UNITED STATES PATENT AND TRADEMARK OFFICE

APPLICATION NO.	FILING DATE	FIRST NAMED INVENTOR	ATTORNEY DOCKET NO.	CONFIRMATION NO.
10/049,834	02/19/2002	Wolfgang Scheibe	842FR/50684	2328

Office Action Summary

DETAILED ACTION

Examiner's Marked Up Figure #3

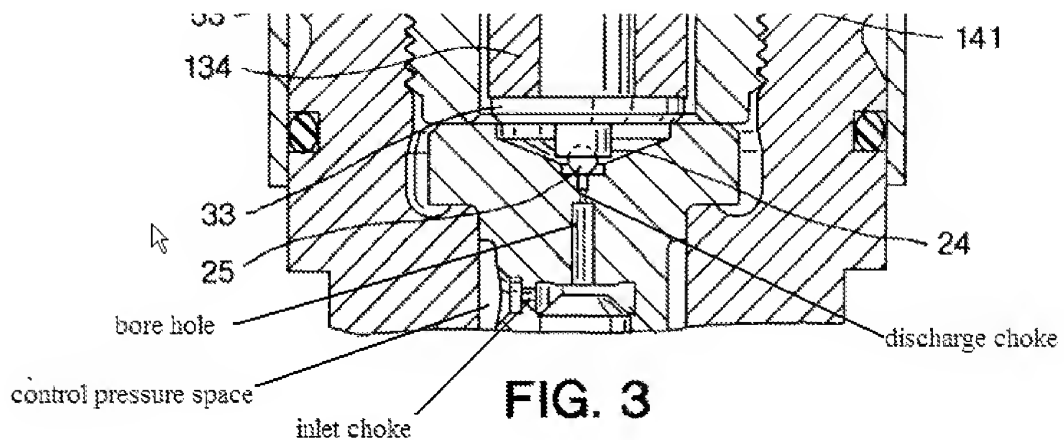
Baumgartner et al. shows a valve comprising: an opening (the path below element 25) having a sealing surface (where element 25 touches the valve seat); a stop (the upper surface of element 54) displaced a distance from the opening; and an electromagnetic control valve including: a valve actuator (139) having an opening position (up) and a closing position (down), the valve actuator including: an actuator sealing surface (25) that engages the sealing surface of the opening when the valve actuator is at the closing position, an actuator stop surface (the bottom surface of element 139) that engages the stop when the valve actuator is at the closing position,

and a valve rod (127) disposed between the actuator sealing surface and the actuator stop surface, wherein when the valve actuator is at the closing position, the valve rod is compressed to a length that is shorter than a length of the valve rod when the valve actuator is at the opening position. It is noted that the length of the valve rod (127) is longer than the distance between the stop surface and the sealing surface (see figure 3, reference number 62), And that just about any material will deform elastically depending on the amount of force applied to it.

Regarding claims 2 and 22, the stop surface of the actuator is significantly larger than the sealing surface (see Fig. 3).

Regarding claims 5 and 25, the valve body is constructed as a sphere, which interacts with the opening for the passage of fluid, forming a seal (See Fig. 3).

Regarding claims 7, 9, the valve actuator (139) is essentially mushroom-shaped, the stem of the mushroom forming the valve rod and the stop surface of the actuator being an annular collar, concentrically surrounding the valve rod in the region of the mushroom cap (24) (see Fig. 3).

Regarding claims 10, 11, 27 and 28, the valve rod is guided axially movably in at least one guide bushing (134) and is disposed at a small distance from the sealing surface of the actuator (see Fig. 3).

Regarding claims 12, 13, 29 and 30 the length of the valve rod is a multiple of its diameter (see Fig. 3) and the sealing surface is formed in the end face of a disk-shaped insert part (the valve seat) (see Fig. 3) and adjoins the control pressure space on the side averted from the sealing surface.

Regarding claims 14, 15, 17-19, 31, 32 and 34-36 the insert part (also forms a stop for the valve needle) is formed in two parts with a first part, which contains an opening for the passage fluid and a discharge choke (see examiners marked up figure 3) and a second part at the control pressure space side, with a bore hole (see examiners marked up figure 3) which connects the control pressure space (see examiners marked up figure 3) with an opening for the passage of fluid. The second part contains an inlet choke (see examiners marked up figure 3) near the bore hole (see examiners marked up figure 3). The pressure space is connected with an inlet choke and the rear end of the valve needle (see examiners marked up figure 3) averted from the nozzle needle seat surface lies in the control pressure space.
